# Modification to run CPU09CMI on 5MHz bus.

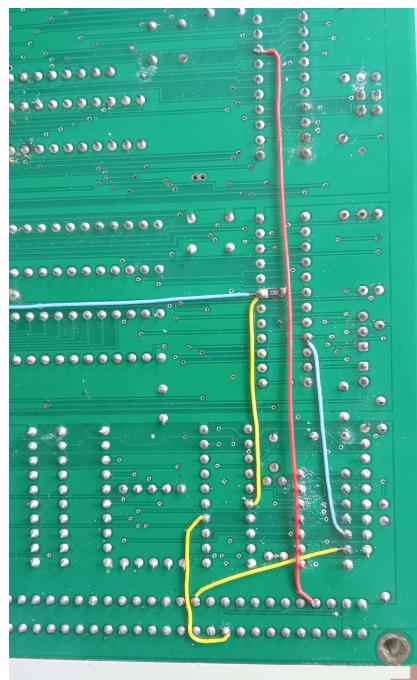
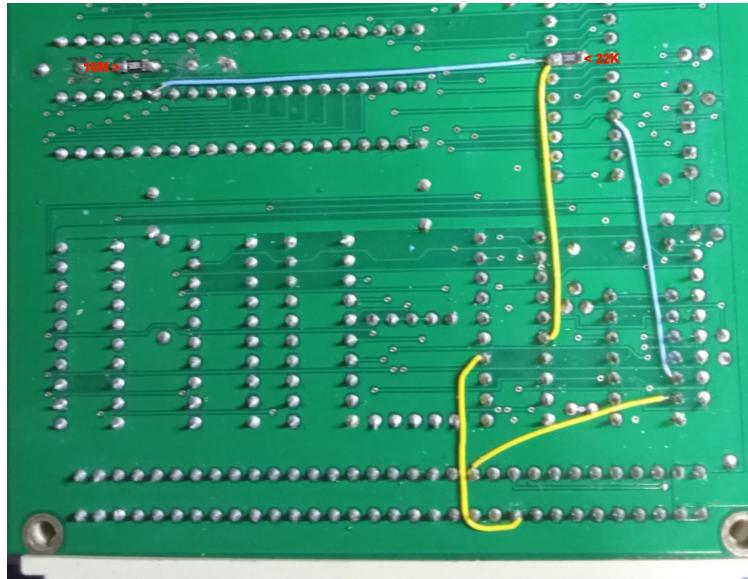
Replace xtal into 20MHz.

Replace C1 and C2 by 15pF.

Place 10M smd between crystal pins.

Replace GAL CMI\_1 by CMI-4\_1

Cut trace between U4-14 and J1 C-21 (B\_VMA-)

For REV:0.9 print only cut trace from J1 A23 to R15

Cut trace between U13-19 and via (OVMA-)

Place 22K resistor between U13-19 and Gnd

Place wire from U6-35 to U13-19 (blue) and U4-6 (Q) (yellow)

Place wire from U4-14 to J1 A-23 (B\_Q) (yellow)

>> Place wire from U14-18 to J1-C29 (red)

Place wire from U3-7 to J1 C-21 (B\_VMA-) , Or:

**To keep CPU09CMI 68x02 compatible  
or need VMA- signal with 68x02 on the bus  
for CPU09GPP or CPU09RAM card.**

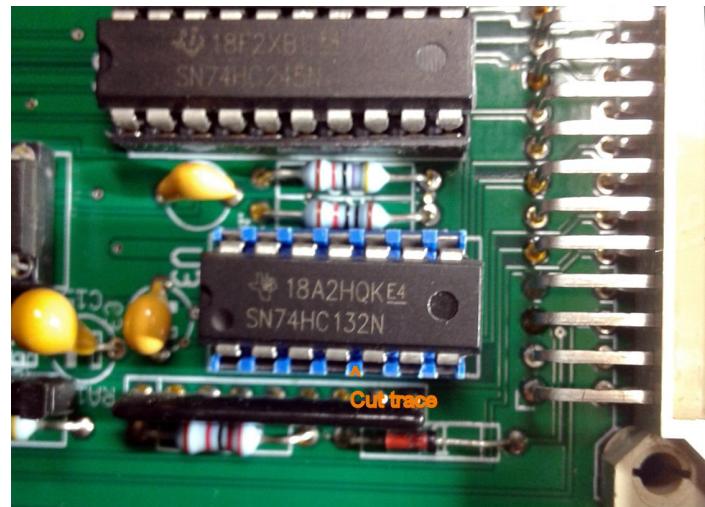
Cut trace between U3-4 and U3-5

Place wire from U3-5 to U13-9 (VMA) (blue)

Place wire from U3-6 to J1 C-21 (B\_VMA-) (yellow)
